**STATE OF CONNECTICUT
CONNECTICUT SITING COUNCIL**

**Petition of BNE Energy Inc. for a
Declaratory Ruling for the Location,
Construction and Operation of a 4.8 MW
Wind Renewable Generating Project on
Winsted-Norfolk Road in Colebrook,
Connecticut (“Wind Colebrook North”)**

Petition No. 984

**REPORT OF WILLIAM F. CARBONI
REGARDING BNE’S D&M PLAN**

FIGURE 1
 Area tributary to Temporary Sediment Trap 3 and Stormwater Pond 1

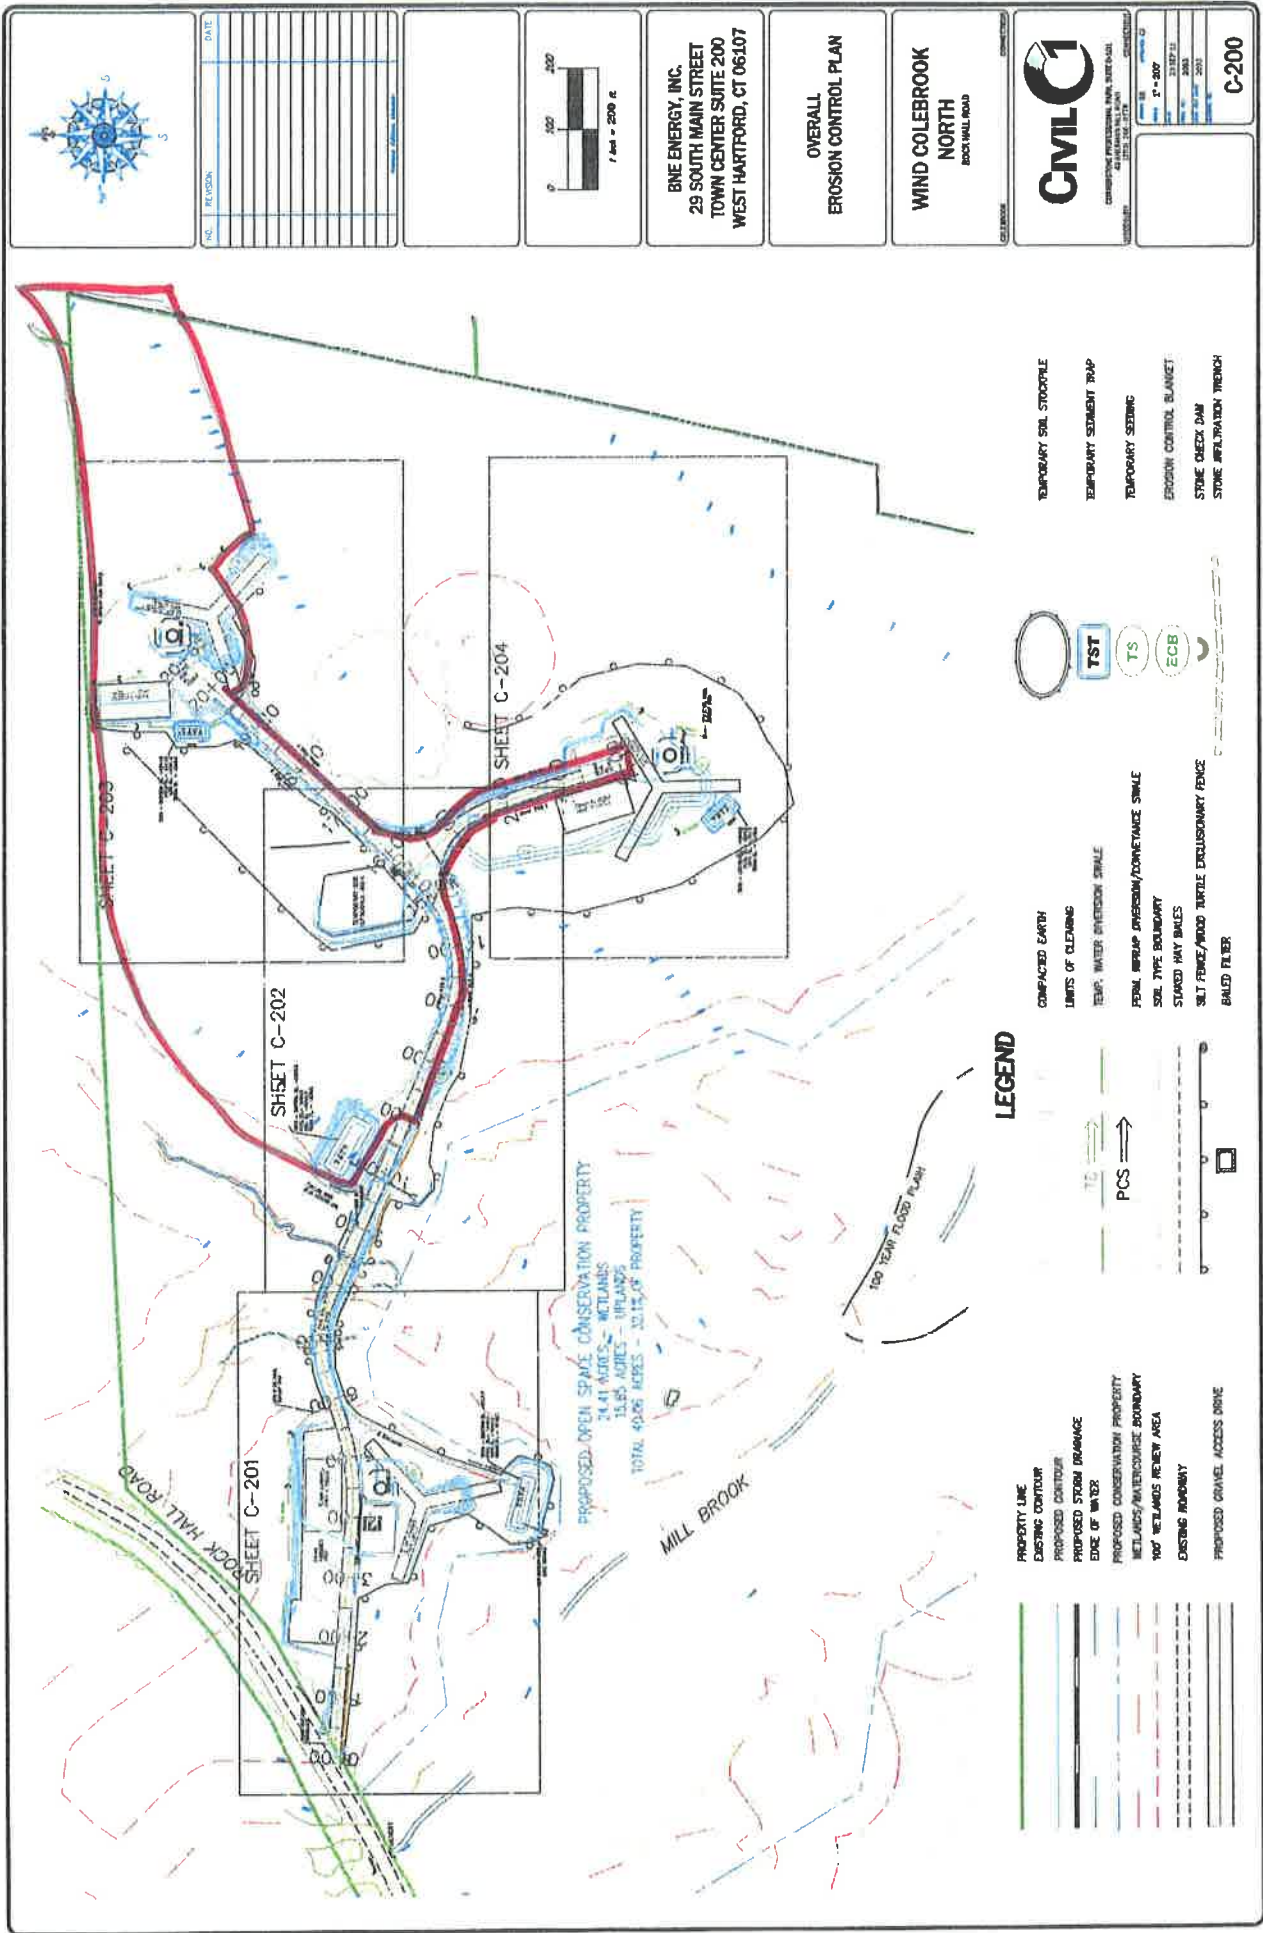
14. There are several errors in the Detention Study. The watershed boundaries are not accurately depicted in the studies. In particular, the area tributary to Temporary Sediment Trap ("TST") 3 and Stormwater Pond 1 is underestimated. These facilities are in the same location and should have the same tributary area. The only boundary map provided is for the Detention Study. (See Drainage Area Map D-100, included in Appendix D of the Stormwater Management Plan.) In Appendix K of the Stormwater Management Plan, the Detention Study shows the area

tributary to Pond 1 as 5.70 acres. In Appendix C of the Erosion and Sediment Control Plan, the area tributary to Temporary Sediment Trap 3 is 4.85 acres. A tributary area of 5.70 acres requires use of a Temporary Sediment Basin instead of a Temporary Sediment Trap. The criteria for sediment basins are more rigorous than those for a sediment trap.

15. Attached to this report is Figure 1, which shows the area tributary to TST 3 and Pond 1. According to my analysis, the tributary area is approximately 10.9 acres. The underestimation of the tributary areas also has significant consequences for the design of the detention pond. As currently calculated in the study, the maximum elevation in the pond is 1269.40 during a 100-year storm. The spillway elevation is 1269.25. The top of the berm is 1270.0. As currently configured, the spillway will be carrying about 1 cfs during a 100-year storm and the pond does not provide one-foot of freeboard. Section 5-9 of the 2002 Guidelines requires a minimum of one foot of freeboard between the 100-year routed water surface and the top of the embankment. If the actual tributary area to the pond is about 11 acres, rather than the 5.7 acres used in the study, the pond will fail.
